CHANGE/ERRATA INFORMATION

ISSUE NO: 1 11/94

Title: 2280 Series Service
Part Number: 753111
Print Date: February 1985
Rev. & Date: 2, 1/90

Figure A.

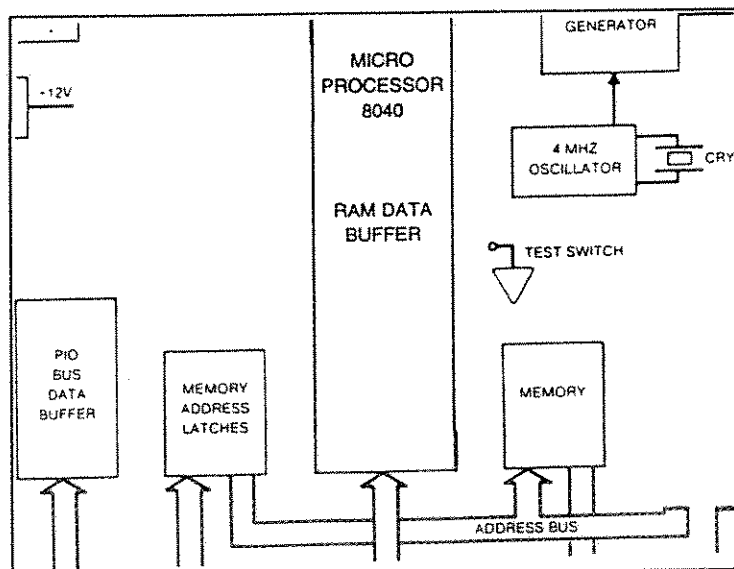
On page 341-2, Figure 341-1, delete the RAM DATA BUFFER, add it inside the MICRO PROCESSOR and change MICRO PROCESSOR 8039 to 8040 as shown in Figure A.

Figure B.

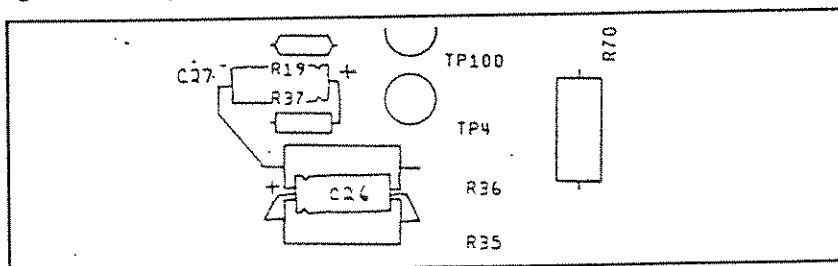
ADD: C26, 27/CAP,AL,47UF,+75-20%, 25V/655191/89536/655191/2

On page 164-15, Figure 164-5, add C26 and C27 as shown in Figure B.

Figure C.

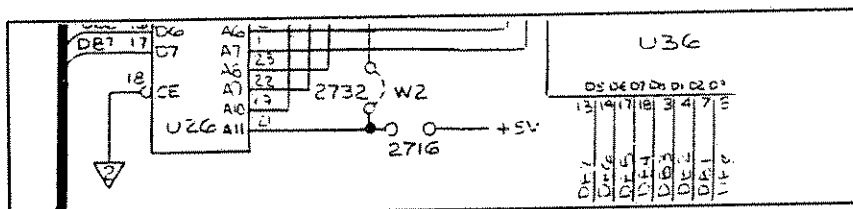
CHANGE: U26/IC,2K X 8 EPROM (PROGRAMMED)/655555/89536/655555/1/1
 TO: U26/IC,4K X 8 EPROM (PROGRAMMED)/655555/89536/655555/1/1

On page 161-F2, Figure 161-7, change the location of jumper W2 to 2732 as shown in Figure C.
